Jacobs Engine Brake Service Letter E485

SUBJECT: Master Piston Retainer Design Change and Field Upgrade

**MODELS AFFECTED: Caterpillar 340A and 340B
(Lightweight Housings Only)**

DATE: October 28, 1998

Figure 1

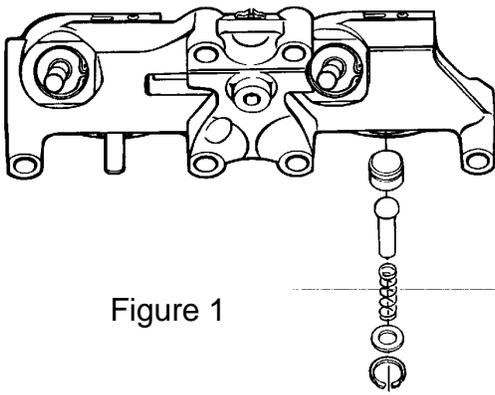
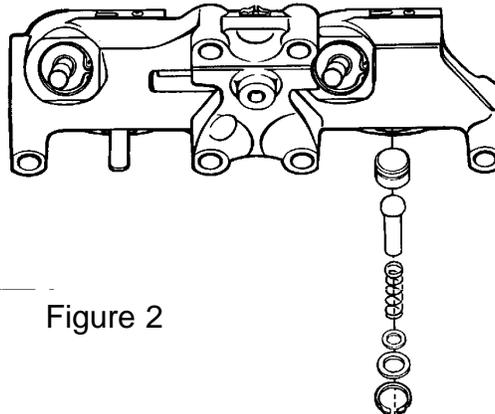
The new design replaces the original single Master Piston Retaining Washer with a two-washer retaining system. This change provides the Master Piston Pushrod with a greater range of motion than the previous design, and eliminates the possibility of the Pushrod contacting the Retaining Washer. Though extremely unlikely, in certain cases the stack up of manufacturing tolerances of the engine and engine brake may allow such contact, resulting in the fracture of the Retaining Washer. This in turn would allow the Master Piston Pushrod to fall out of the housing, possibly damaging engine or engine brake components.

This upgrade requires the replacement of the existing single Master Piston Retaining Washer (Figure 1 below) with the new two-washer system (Figure 2 below). Refer to the 340 Series Installation Manual, Jacobs P/N 019950B (Rev. 12/97), when servicing the engine brake. This installation Manual is included in the Jake Brake Retarders Product Reference Guide, Caterpillar Manual Form RENR1370.

1. Remove the housing assembly from the engine.
2. Follow the procedures for removal and inspection of the Master Piston Assembly listed on page 11 of the 340 Series Installation Manual. Remove both Master Piston Assemblies from the housing, and discard the old Retaining Washers.
3. Reinstall the Master Piston Assemblies using the new two-washer retaining system, as shown in Figure 2.
4. Reinstall the engine brake housing as described in the 340 Series Installation Manual.
